Intersection ID: 50587	Main Street: DOWNY_BIRCH_RD	Cross Street: GREAT_LAUREL_RD	Location:	SW
ADA ID: D38CD7C1228B	Ramp Type: Perp	Initial Pass/Fail: Fail	Overall Compliance: No	Severity Score: 13.75

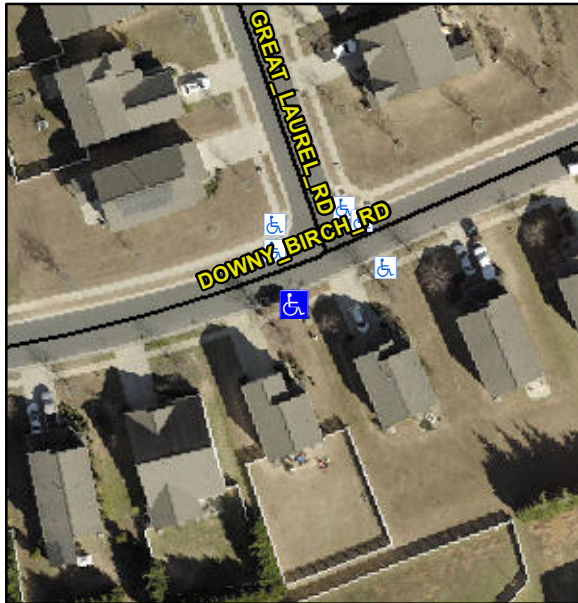
Not Found, R304.2.2, R304.5.3

Possible Solutions:			Compliance	Description	Data	Compliance	Description	Data
Remove & Replace Entire Ramp.	N/A	Ramp Length (in)	47.0	No	Ramp Slope (%)	8.6		
	Yes	Ramp Width (in)	48.0	No	Ramp XSlope (%)	2.1		
	N/A	Flare Type LT	N/A	N/A	Flare Type RT	N/A		
	N/A	Flare Slope LT (%)	N/A	N/A	Flare Slope RT (%)	N/A		
	N/A	Flare Traversable LT?	N/A	N/A	Flare Traversable RT?	N/A		
	N/A	Landing Length (in)	N/A	N/A	DWS Provided?	N/A		
	N/A	Landing Width (in)	N/A	N/A	DWS Contrast?	N/A		
	N/A	Landing Slope (%)	N/A	N/A	DWS Length (in)	N/A		
	N/A	Landing X Slope (%)	N/A	N/A	DWS Full Width?	N/A		
	N/A	Landing Curb? (Y/N)	N/A	N/A	DWS Offset (in)	N/A		
Surveyor Notes: N/A	N/A	Shared Landing?	N/A					
	N/A	Gutter Ponding?	N/A	N/A	Gutter Slope (%)	N/A		
	N/A	Gutter Lip Ht (in)	N/A	N/A	Gutter X Slope (%)	N/A		
	N/A	Painted X Walk1?	No	N/A	Painted X Walk2?	N/A		
		X Walk 1 Direction	To N		X Walk 2 Direction	N/A		
	N/A	X Walk 1 Width (in)	N/A	N/A	X Walk 2 Width (in)	N/A

X Walk 1 Slope (%)	1.2		X Walk 2 Slope (%)	N/A		
		X Walk 1 X Slope (%)	1.9		X Walk 2 X Slope (%)	N/A		
	N/A	Ramp inside XWalk1?	N/A	N/A	Ramp inside XWalk2?	N/A		
		Road Slope (%)	N/A	N/A	Clear Space?	N/A		
PROW/ADA: Not Found, R304.2.2, R304.5.3		Road X Slope (%)	N/A	N/A	Clear Space to XWalk (in)	N/A		
	N/A	Any Obstructions?	N/A	N/A	Storm Grate/Utility Hazard?	N/A		
		Obstruction Type			Storm Grate/Utility Type			
			N/A			N/A		
				Yes	Surface Condition? (G/P)	Good		
	Total Cost:	\$	1850.00

Remove & Replace Entire Ramp.
